Reference: ST-3013/211209-LLFA Response

Response to LLFA comments to
Outline Planning Application 21/4433/OUT

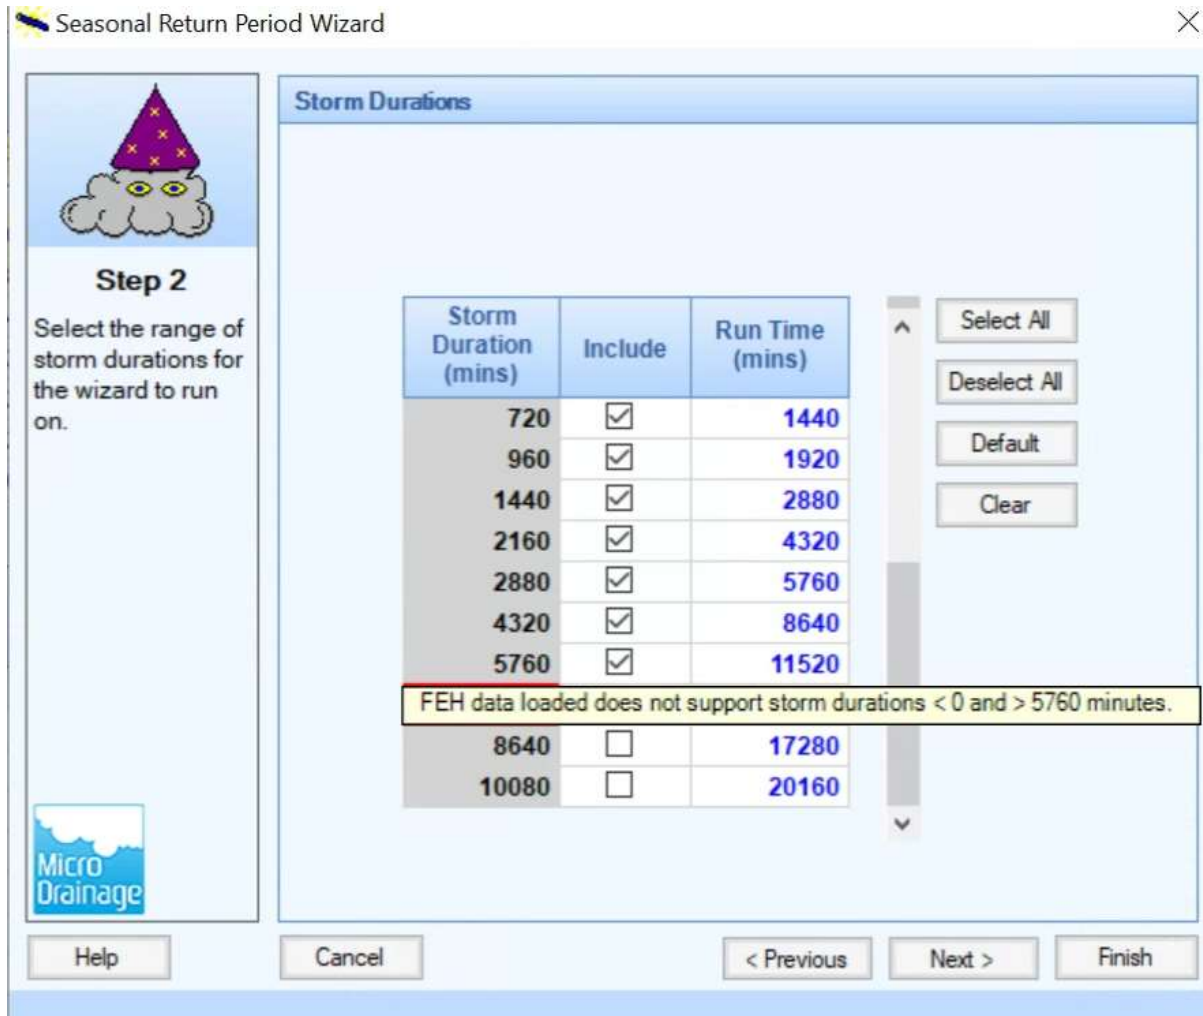
"FSR rainfall data has incorrectly been used for hydraulic calculations. Calculations to show the performance of the system for a range of summer and winter storm durations from 15 minutes up to the 10080 minute (7 day) should be undertaken. For storm durations less than 1 hour, Flood Studies Report (FSR) rainfall data should be used. For storm durations greater than 1 hour, Flood Estimation Handbook (FEH) rainfall data should be used."

FEH rainfall data has been obtained for the site, and the MicroDrainage model have been updated to include this revised data. However, as shown by the screenshot below, FEH rainfall data for the site does not appear to support storm durations greater than 5760 minutes within MicroDrainage. Therefore, output files have been amended to show how the network performs during storms up to and including the 5760 minute 1 in 100 year storm event + 40% Climate Change, based on FEH rainfall data.
